Access Compliance Report Public Rights-of-Way (Curb Ramps)

Main Street: LYNRIDGE_DR Cross Street: OLD_RANCH_RD Location: NE

ADA ID: RPAT210921141322 Ramp Type: Type 3 - Combination 1 Initial Pass/Fail: Fail Overall Compliance: No Severity Score: 2

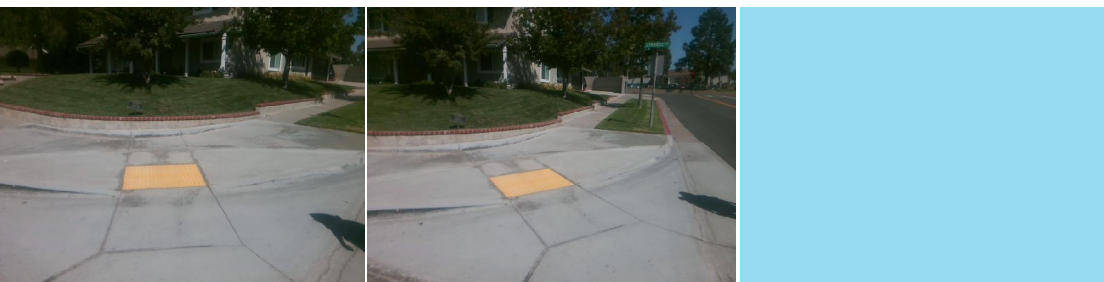
Compliance	Description	Data	Compliance	Description	Data
N/A	Ramp Length LT (in)	106	N/A	Ramp Length RT (in)	94
Yes	Ramp Width LT (in)	62	Yes	Ramp Width RT (in)	66
Yes	Ramp Run Slope LT (%)	5.2	Yes	Ramp Run Slope RT (%)	7.4
No	Ramp Cross Slope LT (%)	3.7	No	Ramp Cross Slope RT (%)	4.2
N/A	Ramp Length (in)	66	N/A	Flare Type LT	
Yes	Ramp Width (in)	48			N/A
Yes	Ramp Run Slope (%)	7.6	N/A	Flare Slope LT (%)	N/A
Yes	Ramp Cross Slope (%)	0.2	N/A	Flare Traversable LT	N/A
N/A	Landing Present	N/A	N/A	Flare Type RT	
N/A	Landing Length (in)	N/A			N/A
N/A	Landing Width (in)	N/A	N/A	Flare Slope RT (%)	N/A
N/A	Landing Run Slope (%)	N/A	N/A	Flare Traversable RT	N/A
N/A	Landing Cross Slope (%)	N/A	N/A	DWS Provided	N/A
N/A	Landing Movement Obstructed?	N/A	N/A	DWS Contrast	N/A
	Landing Movement Type	N/A	N/A	DWS Length (in)	N/A
N/A	Landing Shared	N/A	N/A	DWS Full Width	N/A
N/A	Clear Space	Yes		DWS Offset Type	N/A
N/A	Clear Space To Crosswalk (in)	N/A	N/A	DWS Offset Left (in)	N/A

Remove & Replace Curb Ramp With Two New Directional Ramps or Equivalent.

R304.2.2, R304.5.3, STD 1115
